# Sydney Football Stadium Replacement Concept proposal and Stage 1 Demolition (SSD 9249)

The City of Sydney *objects* to the concept development application for redevelopment of the Sydney Football Stadium and concurrent Stage 1 works including demolition of the existing stadium.

**Figure 2:** Sydney Football Stadium relative to the site boundary and showing public areas (from INSW EIS overview)

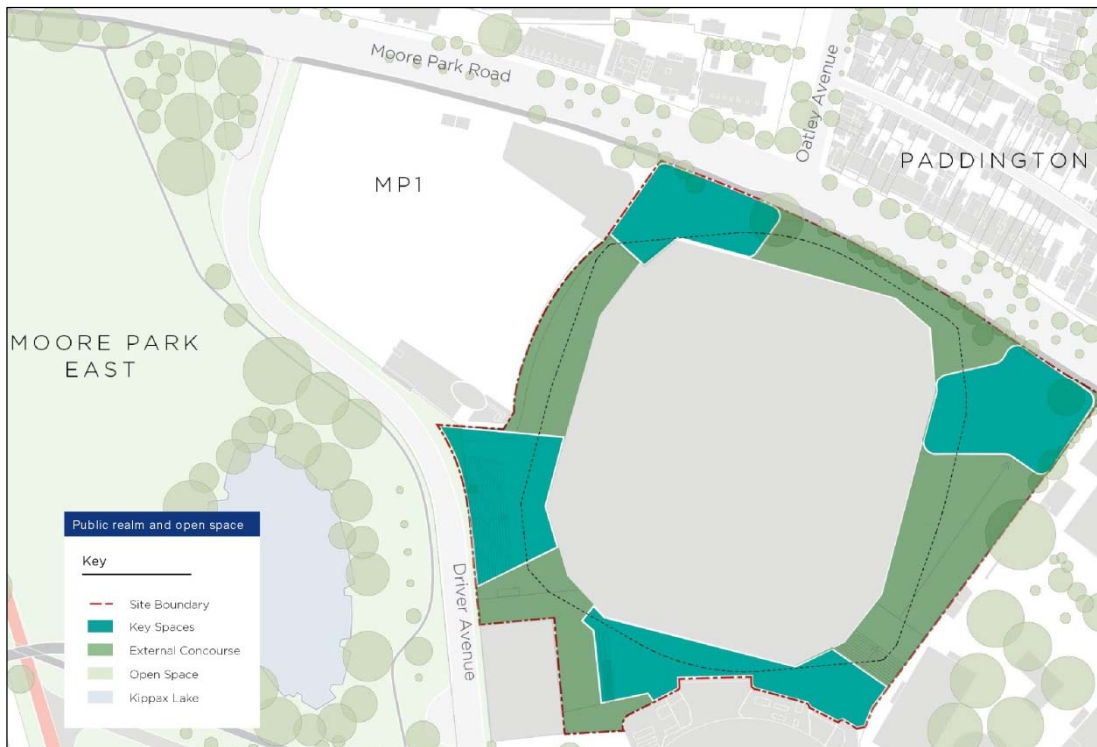
As illustrated in Figure 2, the proposed stadium footprint is too large for the site to contain the full range of enhancements; and compliance and security requirements generated by the proposed use.

The FIFA ‘public access and egress diagram’ (Figure 3) clearly illustrates that large spaces are required around stadiums for secure and safe movement. As evidenced in Figure 2, the proposed envelope significantly constrains these essential movements. Separated access is required for various groups including: spectators, players and officials, media, emergency vehicles and VIPs. The site restrictions only allow three entry points only. However, these are not evenly distributed around the stadium. It is clear that the full range of separated entry conditions would be difficult if not impossible to provide.

**Figure 3.** FIFA requirements Public Access and Egress Diagram

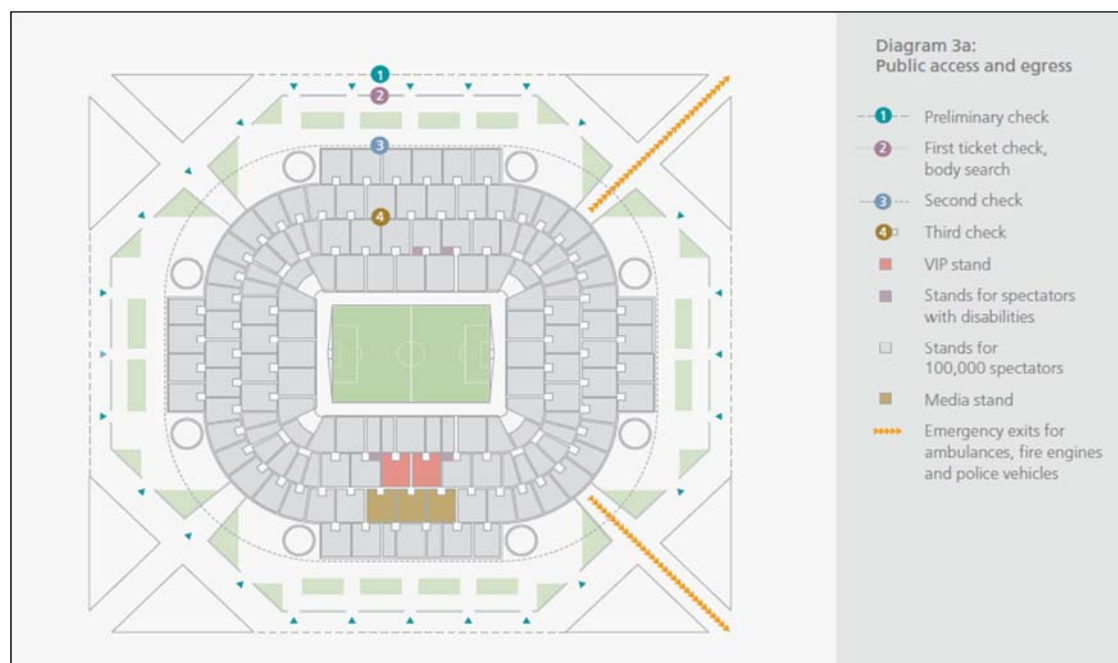
The proposed stairs to Driver Avenue present a safety hazard for patrons entering and leaving the stadium. The movement on stairways particularly the downward movement poses a potential risk to crowds both in normal circumstances, such as at the end of an event or in an emergency.

The effects of pushing and congestion are potentially dangerous if the crowd suddenly surges forward for any reason or an individual suddenly changes direction. The site planning has placed the major entry to the stadium as a stair entry with a rise of over four metres contrary to the UK Guide to Safety at Sports Grounds Spaces for barriers are required at the head of the stair and adequate space to control flow is required at the base of the stairs.

The drawings (Figure 3) illustrate inadequate space for the stairs (i.e. no space is provided at the base of the stairs) and that the space required for safety and security and cannot be provided.
